HISTORIC AND DESIGN REVIEW COMMISSION

August 17, 2022

HDRC CASE NO: 2022-291
ADDRESS: 801 N MAIN AVE
LEGAL DESCRIPTION: NCB 787 BLK 7 LOT 15- 16 & S TRI 53.79 FT OF 10
ZONING: D
CITY COUNCIL DIST.: 1
APPLICANT: Robert Flores/American GI Forum-National Veterans Outreach Program, Inc.
OWNER: American GI Forum-National Veterans Outreach Program, Inc.
TYPE OF WORK: Construction of a 4-story residential structure
APPLICATION RECEIVED: August 01, 2022
60-DAY REVIEW: Not applicable due to City Council Emergency Orders
CASE MANAGER: Edward Hall

The applicant is requesting a Certificate of Appropriateness for approval to construct a 4-story, residential structure at 801 N Main, located within the Downtown Design District.

SHEET TITLE:
SITE PLAN

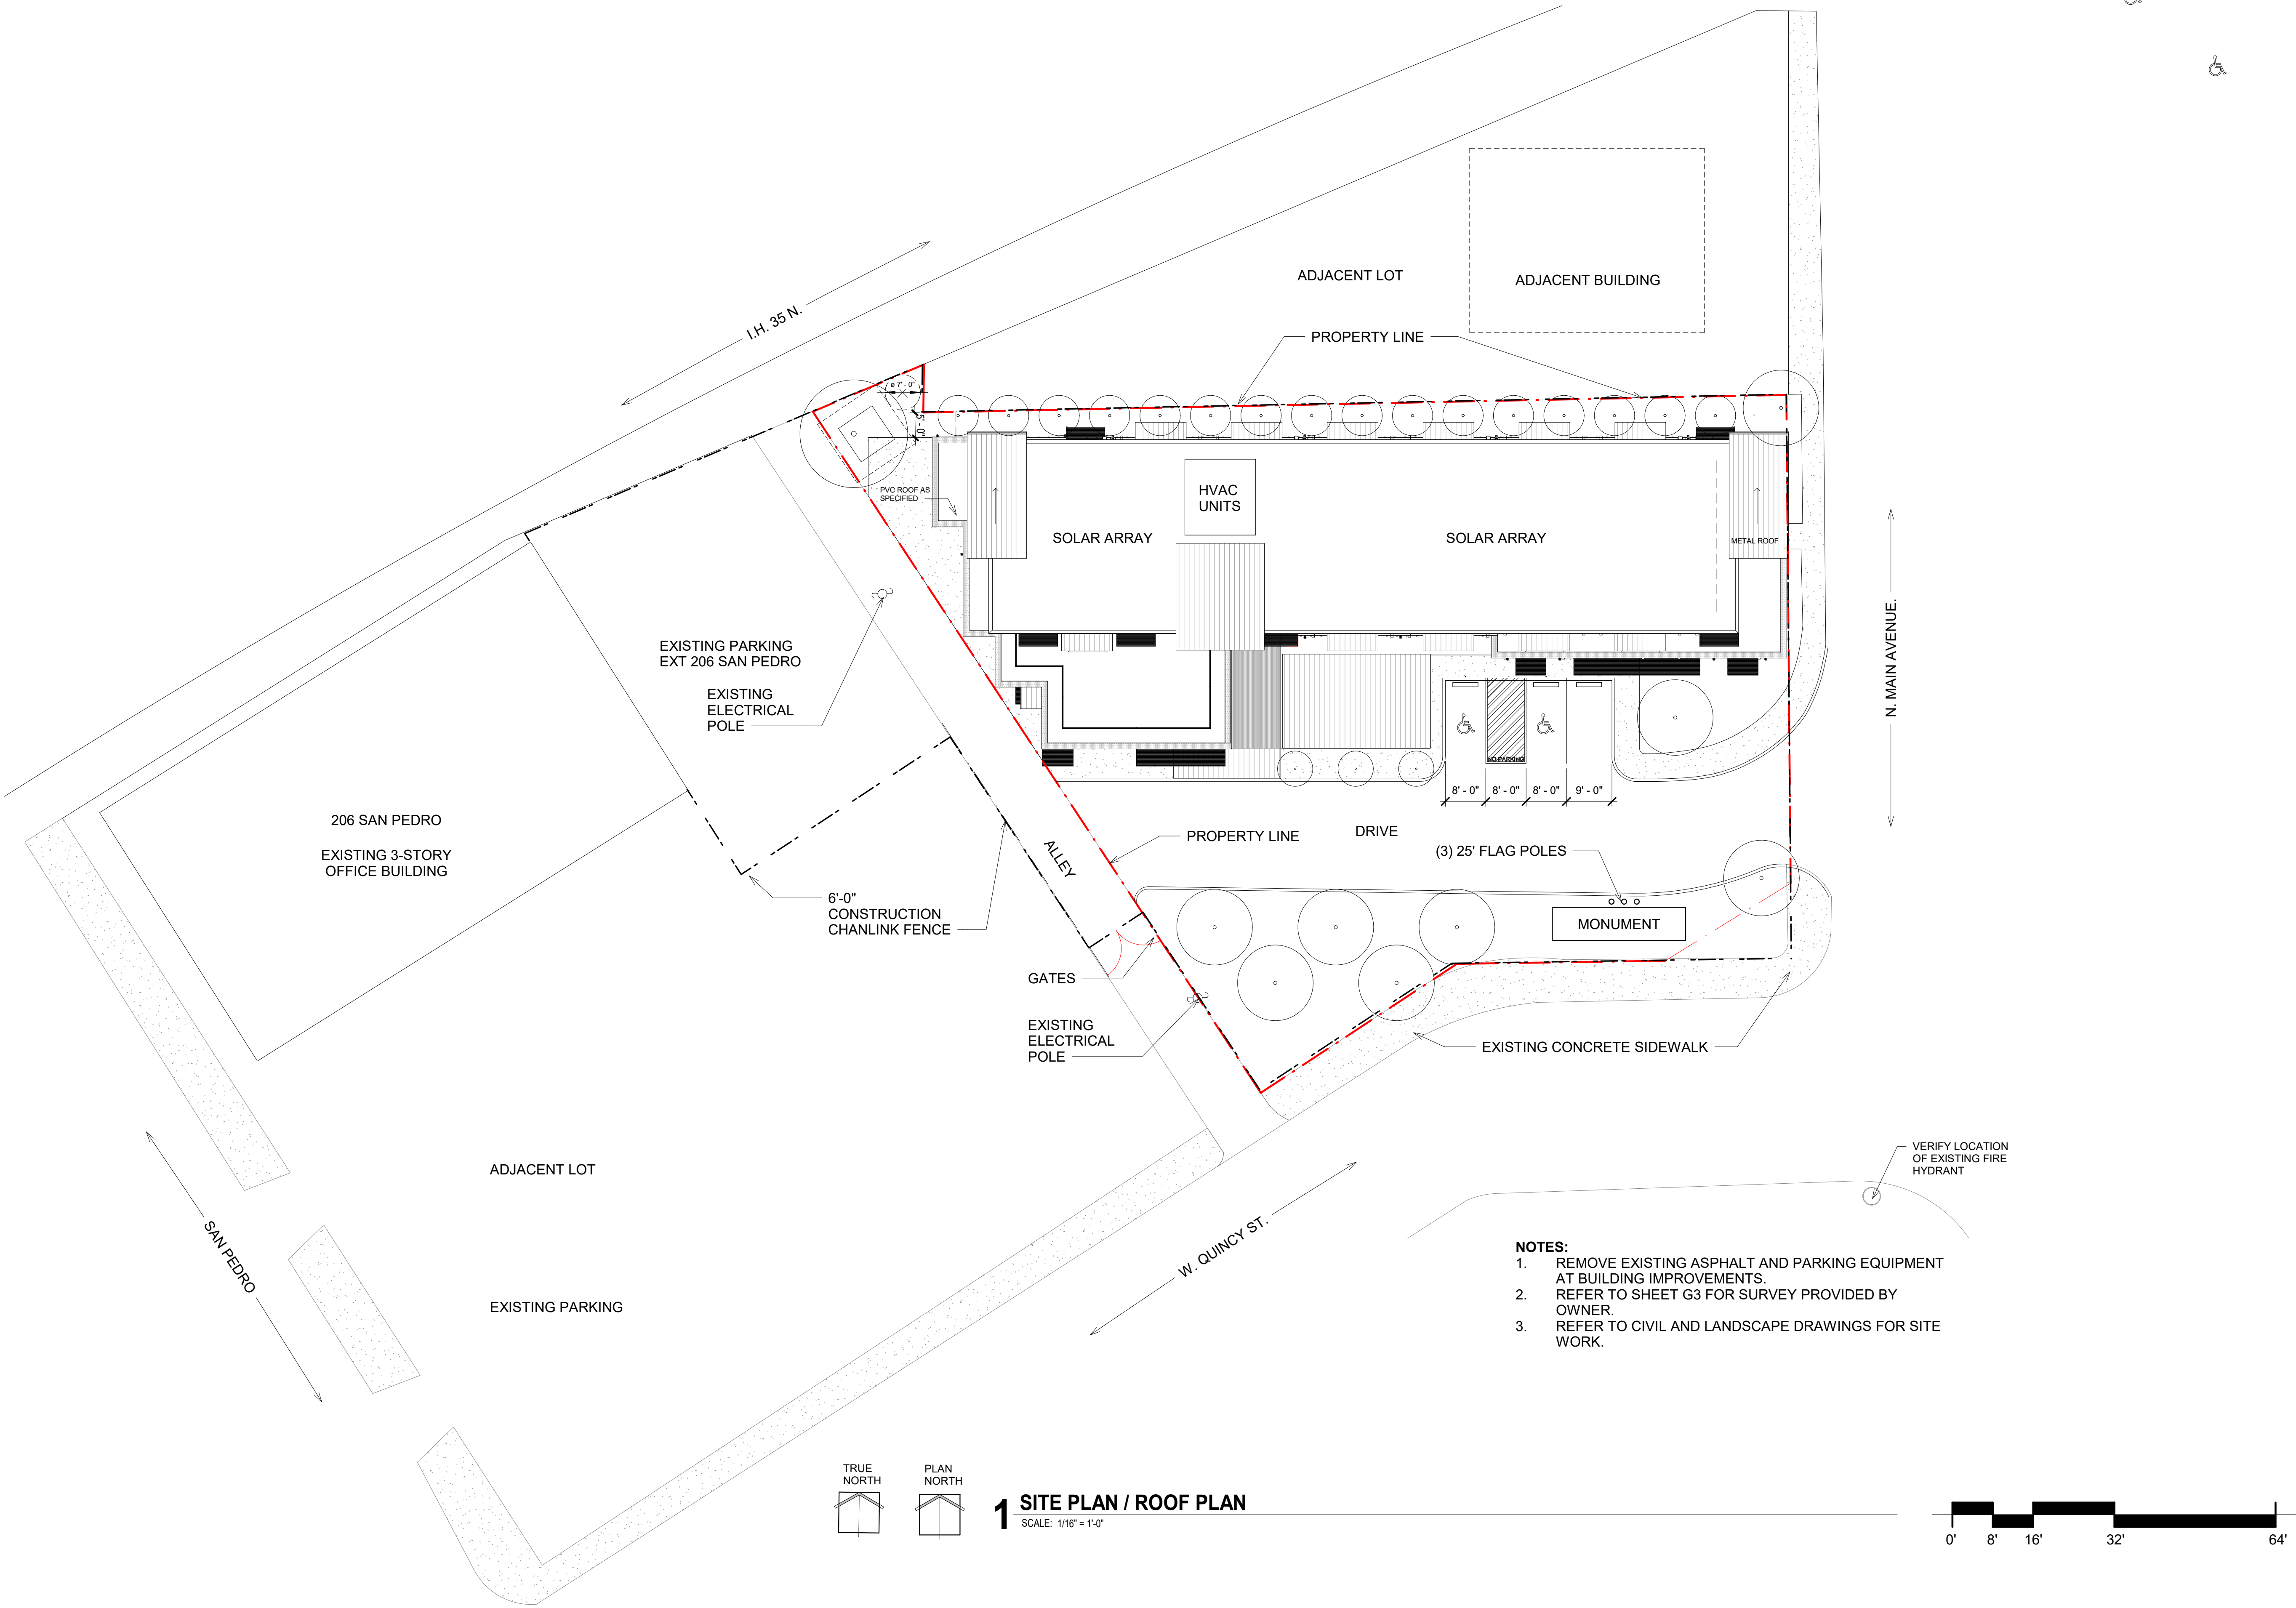
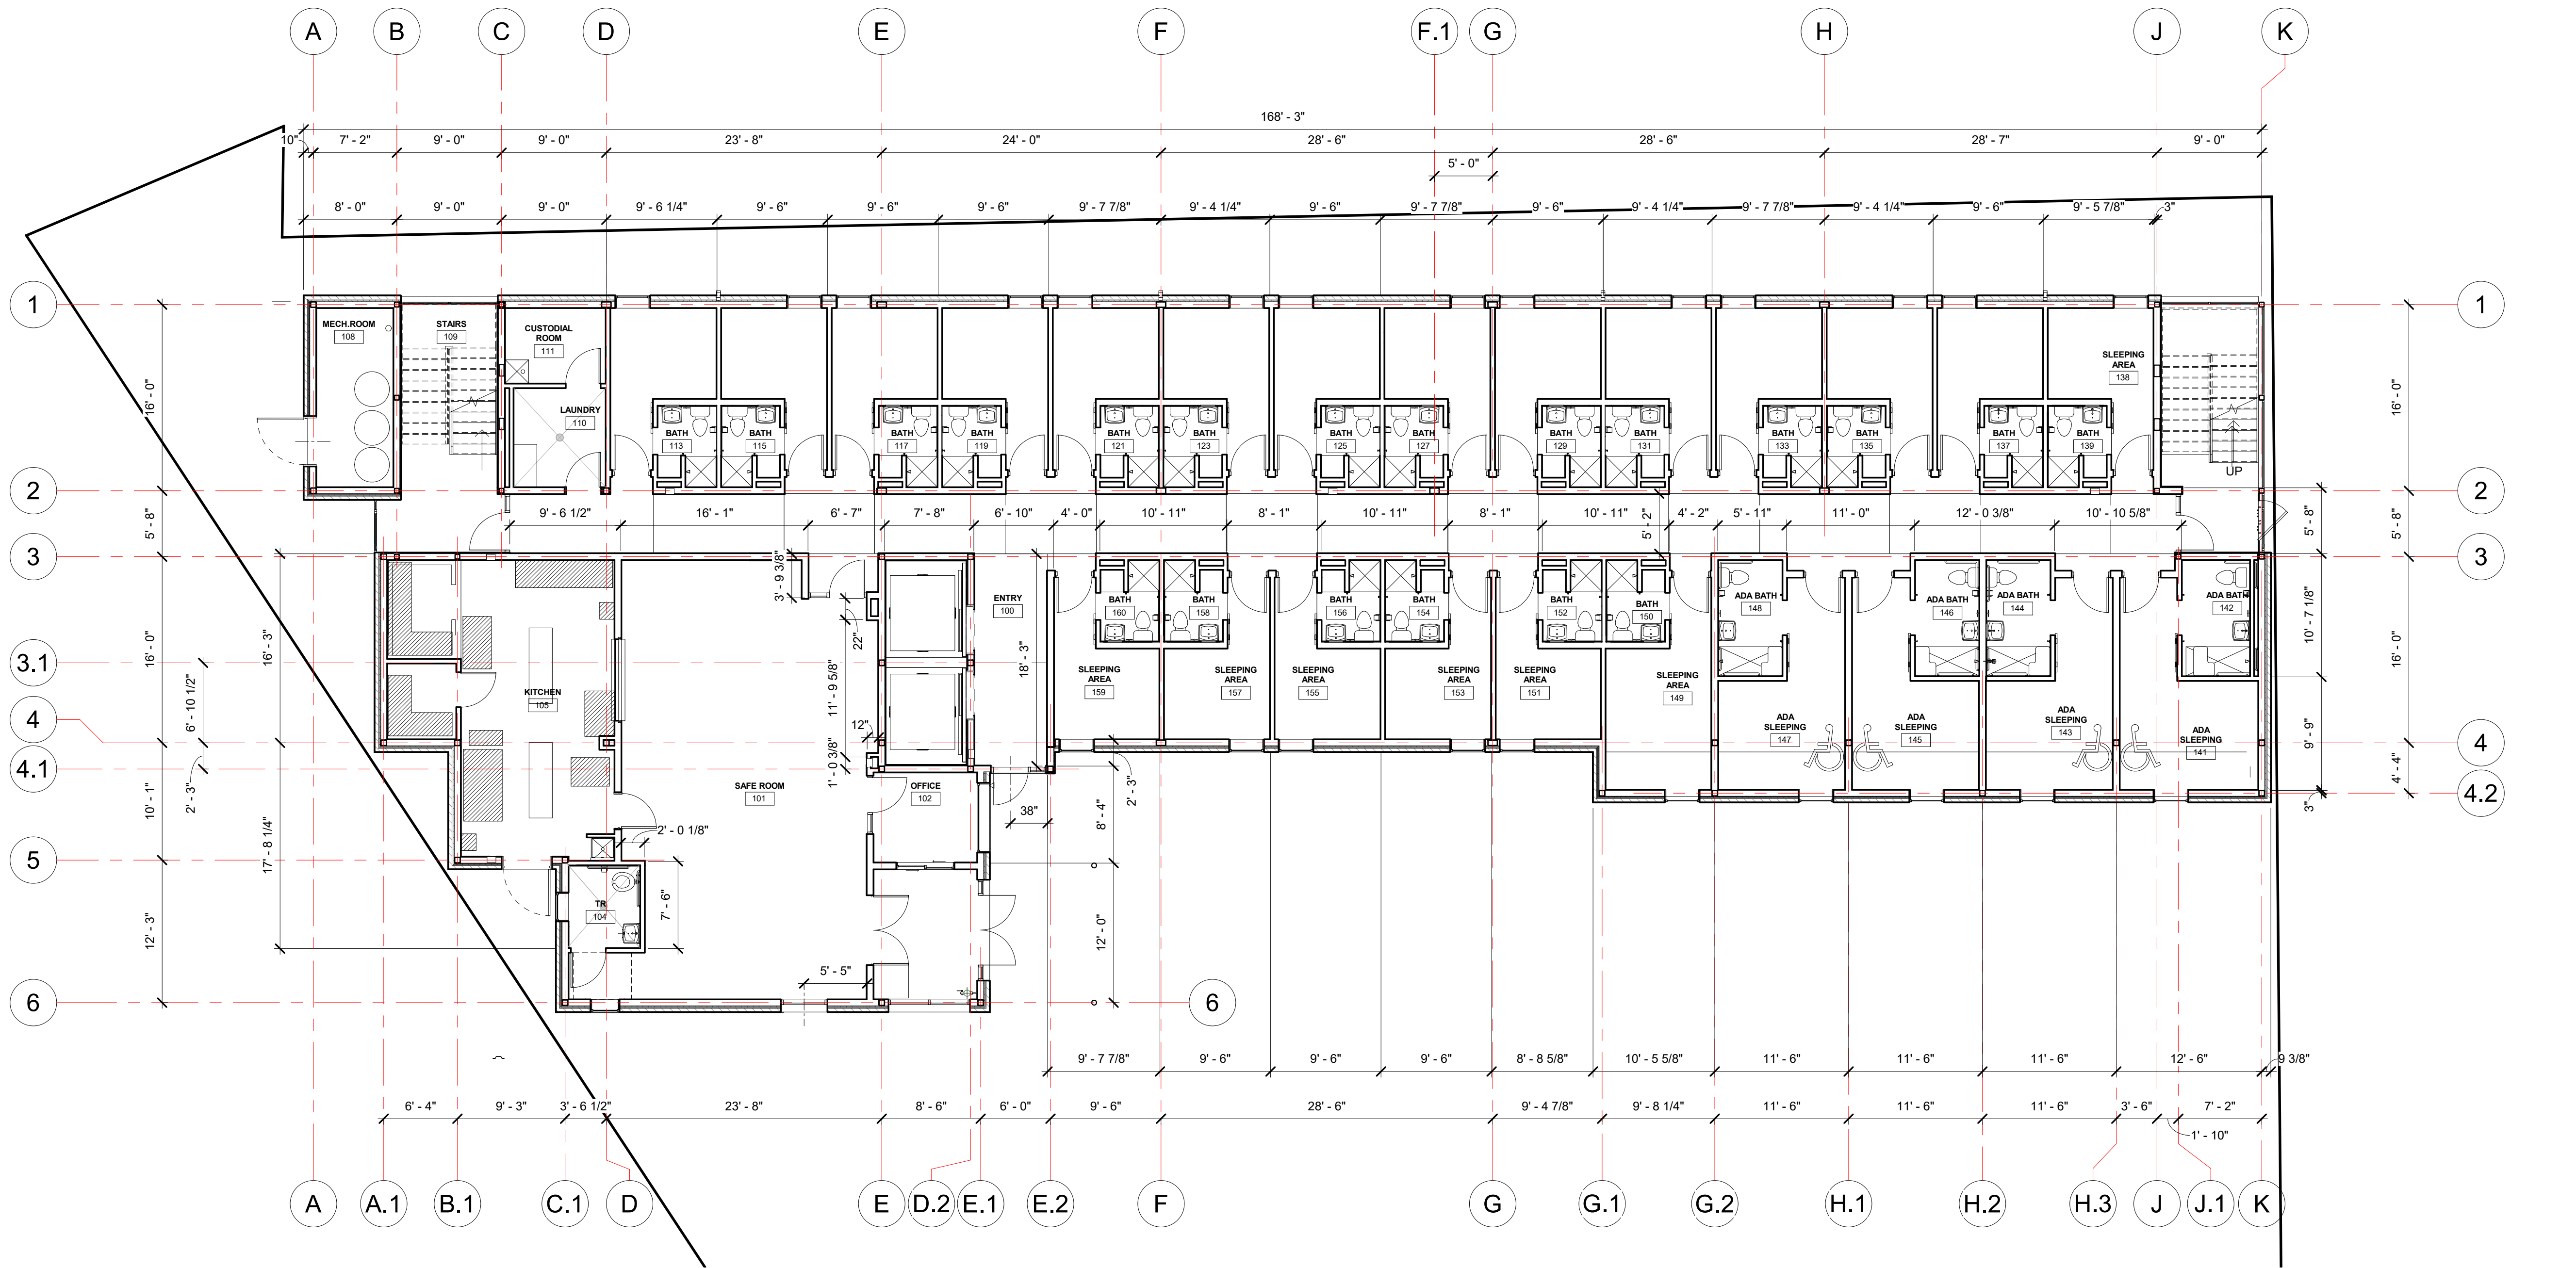
- e. SIDEWALK & SETBACK WIDTH – The applicant has proposed to maintain the existing sidewalks at the public right of way, as well as provide site paving within the site. Staff finds maintaining the existing sidewalks on site to be appropriate, as well as the installation of interior sidewalks.

- f. LANDSCAPE & HARDSCAPE – The applicant has submitted a site plan that notes the installation of various street trees and hardscaping areas. Staff finds the proposed landscaping and hardscaping plans to be appropriate and consistent with the Downtown Design Guide.
